Deviation From Design

DfD : DfD-0006

**Taran Laval – SAAA Builder 7417
Van's Aircraft RV7 - 73918**

RHS VS Skin Mid Mis-Dimple

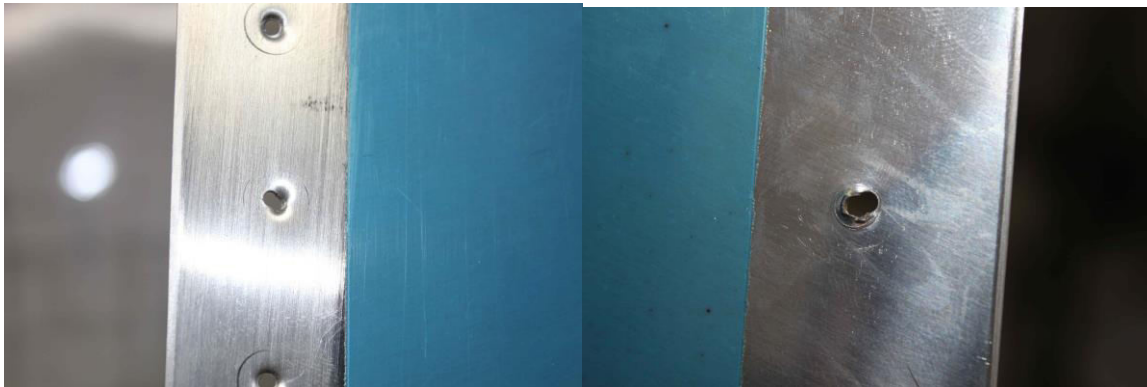
During Dimpling of the Vertical Stabiliser one of the holes midway up the aft edge of the right hand side of the Vertical Stabiliser became elongated after the dimple die was actuated while not properly set.

In some cases like your top picture it may work to go to the next size rivet up to fill this slightly larger hole, also an oops rivet can be used in small quantities when building. For the figure eight hole where you almost completely missed the actual hole you can try flattening out the miss dimple and just going on like normal. I have heard of people filling the void with "JB" weld to give it a little added structure. A nother option is to abaddon that hole and put two new ones in, one to ether side of the one you skip. If you are worried about structural integrity or just don't want people to see an extra dimple in the middle of no where there is always the option of new parts.

“go to the next size rivet up to fill this slightly larger hole, also an oops rivet can be used in small quantities when building.”

These rivets are used to replace drilled out rivets where the hole may have been oversized. Typically the head on these rivets is smaller than the normal AN426 rivet, so an oversized AD3 hole can be opened to an AD4 size and the head will be similar to the original rivet.
